Access Compliance Report

Public Rights-of-Way

(Curb Ramps)

Intersection ID: 16513	Main Street: BILTMORE_DR	Cross Street: COLVILLE_RD	Location: SW
ADA ID: 946F2419768D	Ramp Type: Perp	Initial Pass/Fail: Fail	Overall Compliance: No
Severity Score: 13.75			
Codes/Mitigation Info/Possible Solution		Field Measurements/Component Compliance

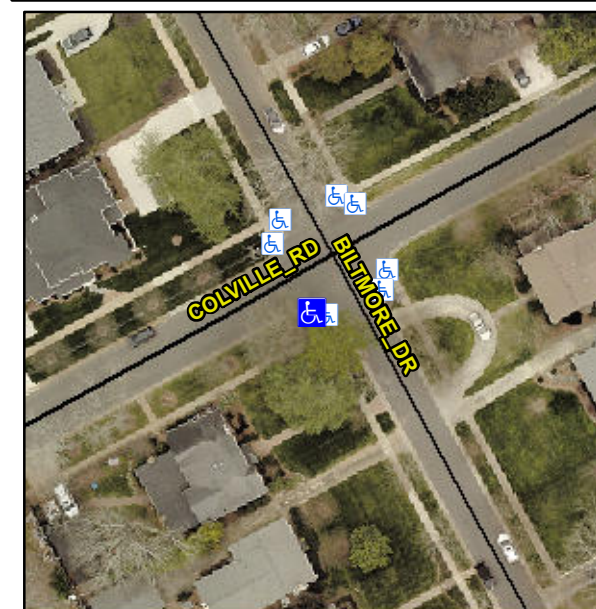
R304.2.2, R304.5.3

Compliance	Description	Data	Compliance	Description	Data
N/A	Ramp Length (in)	60.0	No	Ramp Slope (%)	11.1
Yes	Ramp Width (in)	48.0	No	Ramp XSlope (%)	3.2
N/A	Flare Type LT	N/A	N/A	Flare Type RT	N/A
N/A	Flare Slope LT (%)	N/A	N/A	Flare Slope RT (%)	N/A
N/A	Flare Traversable LT?	N/A	N/A	Flare Traversable RT?	N/A
N/A	Landing Length (in)	N/A	N/A	DWS Provided?	N/A
N/A	Landing Width (in)	N/A	N/A	DWS Contrast?	N/A
N/A	Landing Slope (%)	N/A	N/A	DWS Length (in)	N/A
N/A	Landing X Slope (%)	N/A	N/A	DWS Full Width?	N/A
N/A	Landing Curb? (Y/N)	N/A	N/A	DWS Offset (in)	N/A
N/A	Shared Landing?	N/A			
N/A	Gutter Ponding?	N/A	N/A	Gutter Slope (%)	N/A
N/A	Gutter Lip Ht (in)	N/A	N/A	Gutter X Slope (%)	N/A
N/A	Painted X Walk1?	No	N/A	Painted X Walk2?	N/A
	X Walk 1 Direction	To N		X Walk 2 Direction	N/A
N/A	X Walk 1 Width (in)	N/A	N/A	X Walk 2 Width (in)	N/A
	X Walk 1 Slope (%)	1.0		X Walk 2 Slope (%)	N/A
	X Walk 1 X Slope (%)	1.4		X Walk 2 X Slope (%)	N/A

Remove & Replace Entire Ramp.
